RE: Opposition to Application for a Rail Spur, by the Valero Refinery, to the City of Benicia

SUBJECT: Opposition to Application for a Rail Spur, by the Valero Refinery, to the City of Benicia

Date: April 5, 2016
To: Valero CBR File
From: Amy Million, Principal Planner
Re: **Benicians for a Safe and Healthy Community Petition Submitted at City Council Meeting- April 4, 2016**

Benicia Valero CBR, 202115.01
Figure 3-3
Site Plan

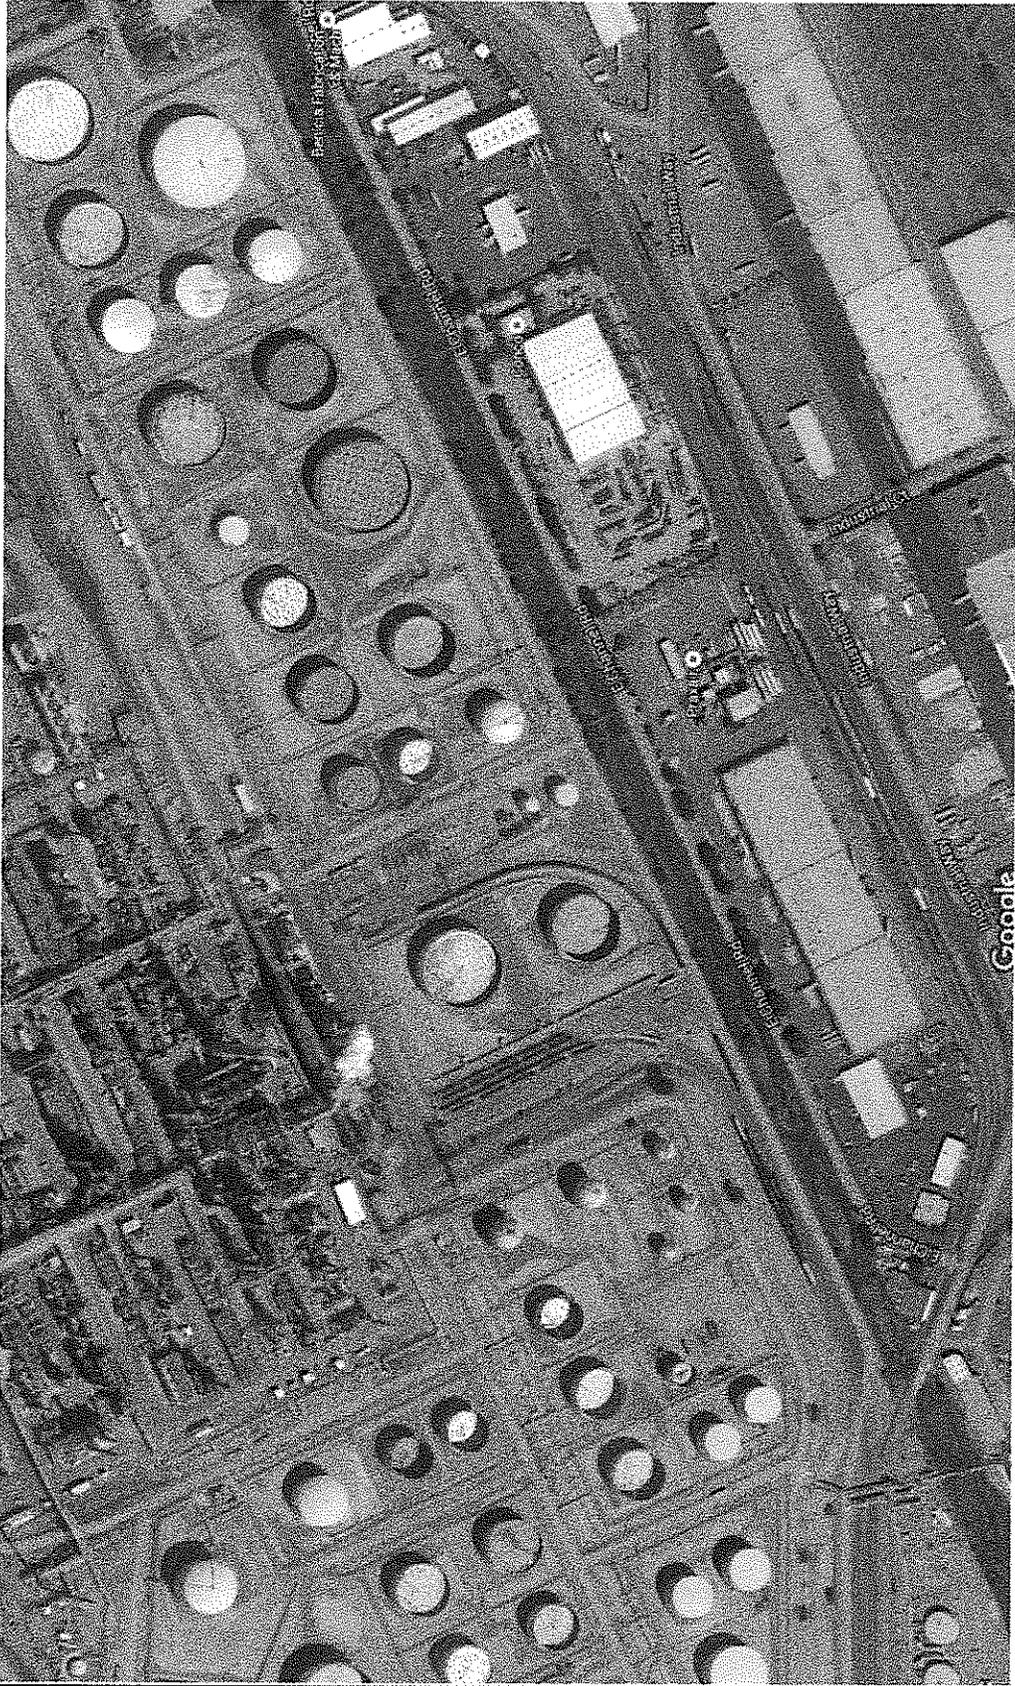
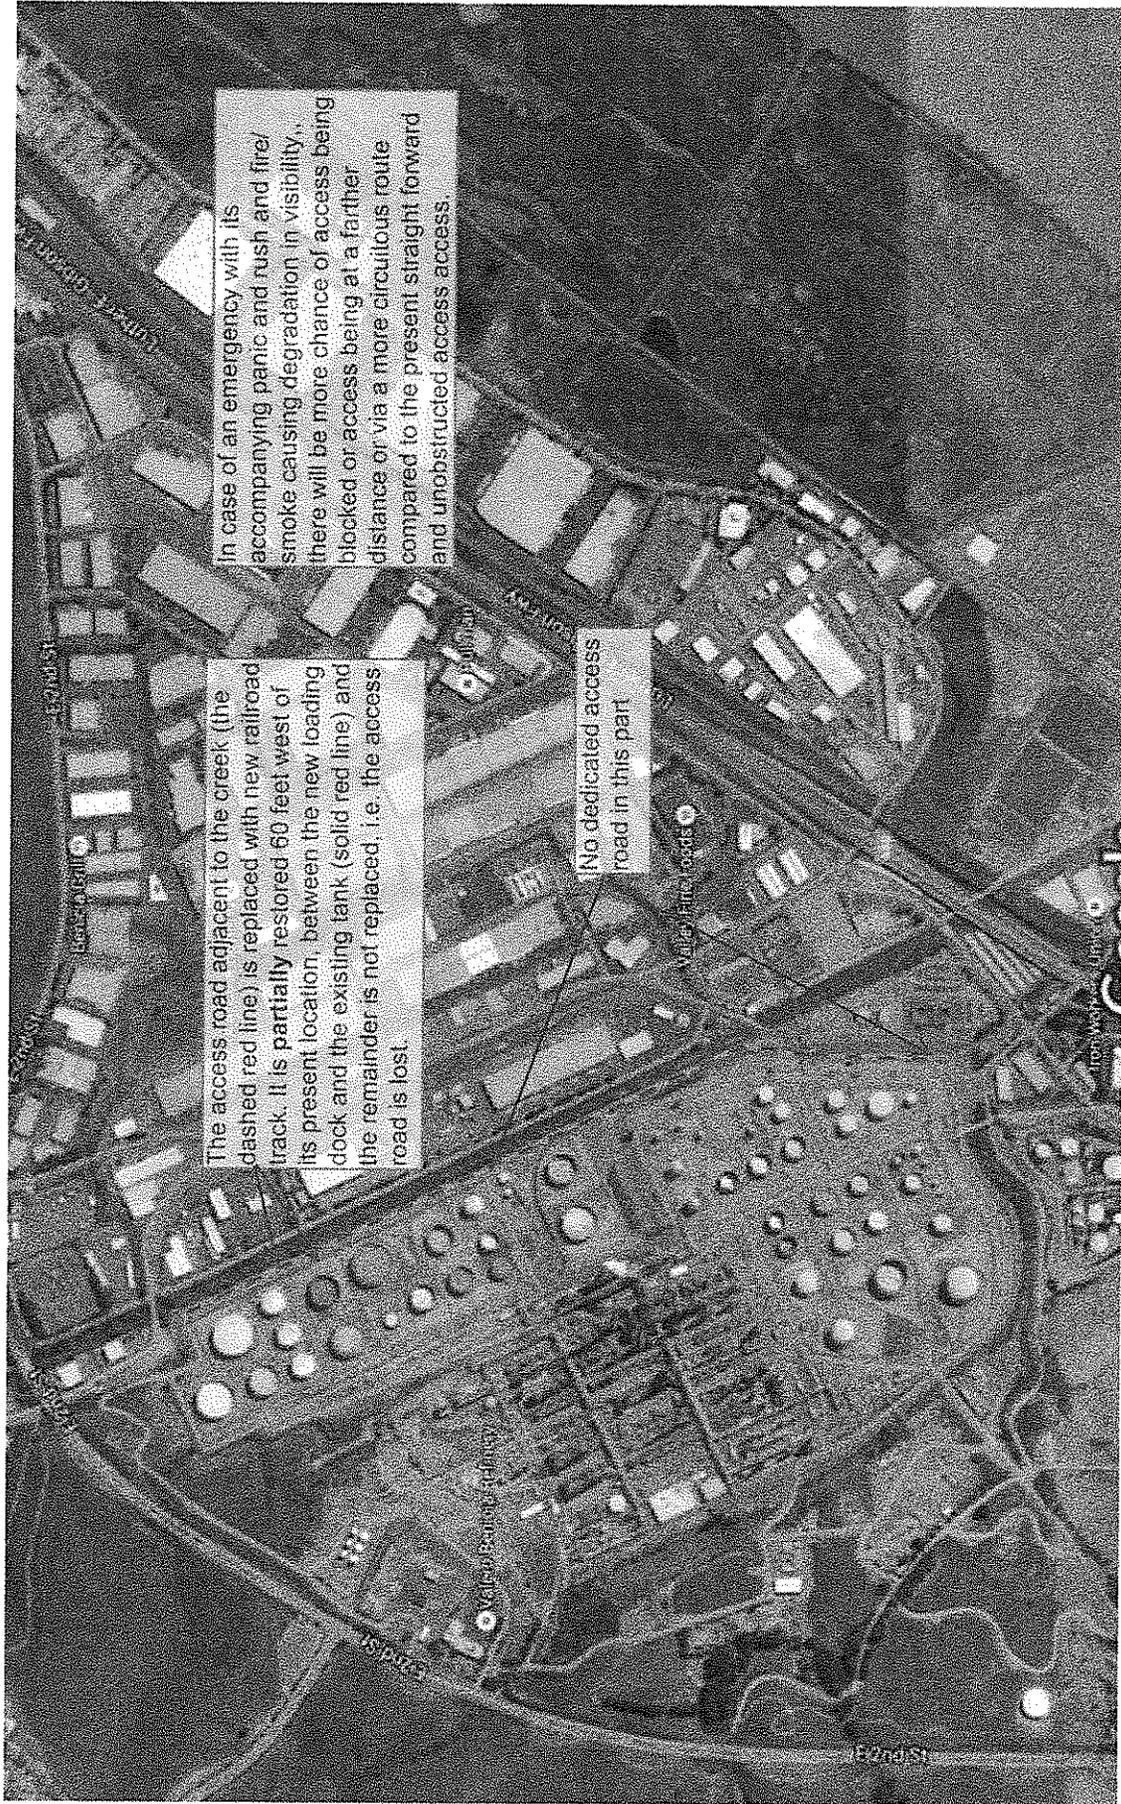
3. The proposed CBR project eliminates this service road and builds a railroad track in its place where a 50 car train could be parked over extended period of time every day and night, 365 days a year. Valero proposes to construct a 1900 feet partial replacement service road 60 feet away and parallel to the present road on its south-east (Figure 3-3 of DEIR enclosed at the end of this letter). Along this segment (Section B-B of Figure ES-3 of DEIR) there will be a substantial degrading of emergency vehicle access to the eastern most train (departure track) and the middle train, as well as the Sulfur Spring. Along the remaining 1755 feet segment (Section A-A of Figure ES-3 of DEIR) there is actually no emergency vehicle access at all where potentially up to 5 trains could be in an emergency situation with no access to them or to the Sulfur Spring banks to contain any hazardous spill or suppress fire/explosions.

We note that both Valero proposal, and DEIR which basically cuts and pastes Valero's proposal in their DEIR, fail to mention this major change and its implications when they describe the key component of the project (see page 2-6 of DEIR). We can understand why Valero might not want to emphasize this negative point by discussing the degradation of accessibility and fire/flood protection when they apply for permit, however, we are at a loss why the City Planning department and the City consultants in charge of EIR, who are the technical parties with the responsibility of clarifying ramifications of the proposed project, failed to do so.

In case of an emergency with its accompanying panic and rush and fire/smoke causing degradation in visibility, there will be more chance of access being blocked or access being at a farther distance or via a more circuitous route compared to the present straight forward and unobstructed access access.

Figure 3-1 – Setback with defined bank (see exceptions Section 20-30.040.D.4.)

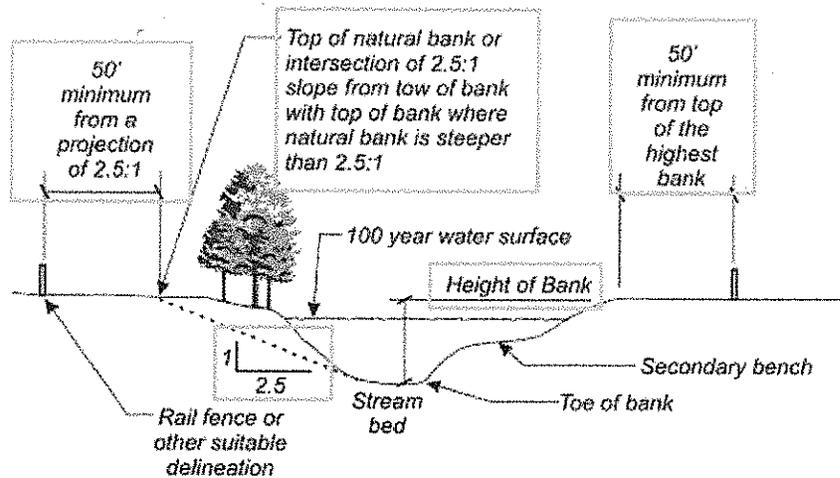
City of Benicia Municipal Code's section regarding the setback is very brief. This might cause ambiguity for some as to what really constitutes a "development", and what is the meaning of "top of the bank"? That is why I have enclosed at the end of this letter similar provision for the City of Santa Rosa, where "development" is defined in detail, and "top of the bank" geometry is graphically defined in sketches. Please note that roads and walls are defined as development and are prohibited in the setback. Also please note that the top of bank definition requires drawing a 2.5 to 1 line from toe of the stream bank to the ground surface.
